Hamza Textiles Ltd.

29 January 2025

2. Observations

Observation-1: DEA report needs to be reviewed against lateral loading. (Building-1: Dyeing Production Shed (Block A))

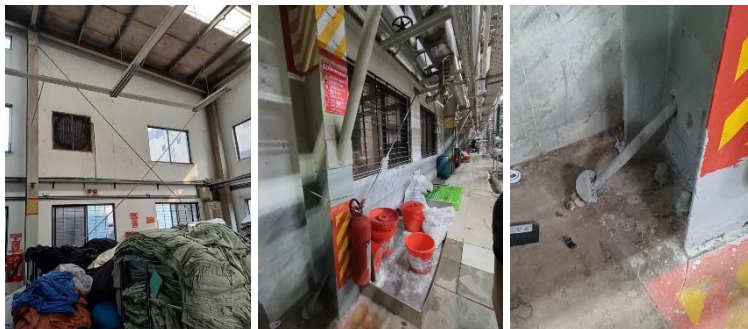
Description: The prepared DEA report needs to be reviewed against lateral forces. Submit the DEA report to the RSC for detailed review.

Observation-4: DEA report needs to be reviewed against lateral loading. (Building-2: Four Storied Steel Building (Hamza-1) (Part-1, 2 & 3))

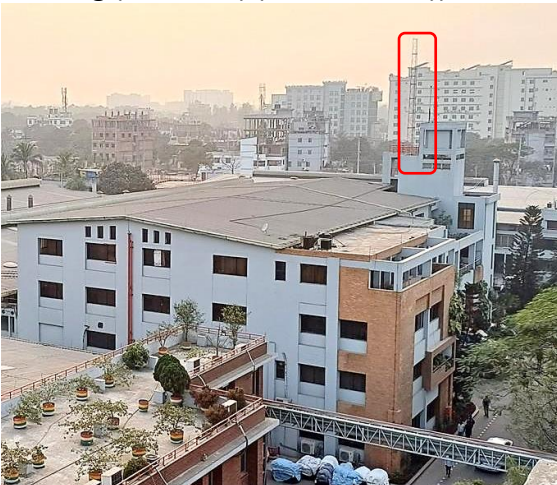
Description: The prepared DEA report needs to be reviewed against lateral forces. Submit the DEA report to the RSC for detailed review.

Observation-7: Discrepancy between the provided drawing and site condition for Part-1. (Building 3)

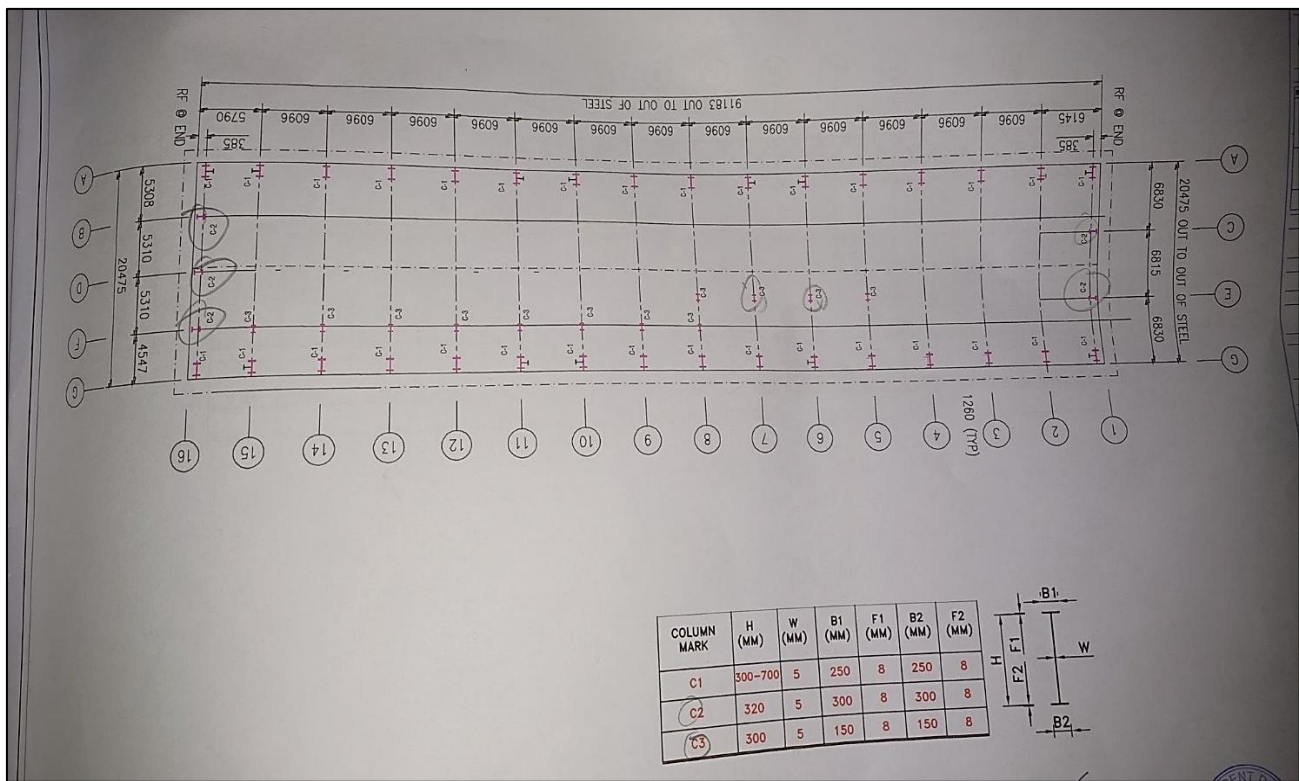
Mezzanine steel column C3 found tapered instead of regular straight shape

Steel column C2 size found F-255 X W-365 instead of F-300 X W-320

End grid rafter was not rested on column C2, no details found. Also, reduced section size was observed at the top level.

Description: During the inspection, discrepancies were observed between the provided drawing and actual site condition for Part-1. The building engineer is required to update the as-built drawing reflecting actual site condition.
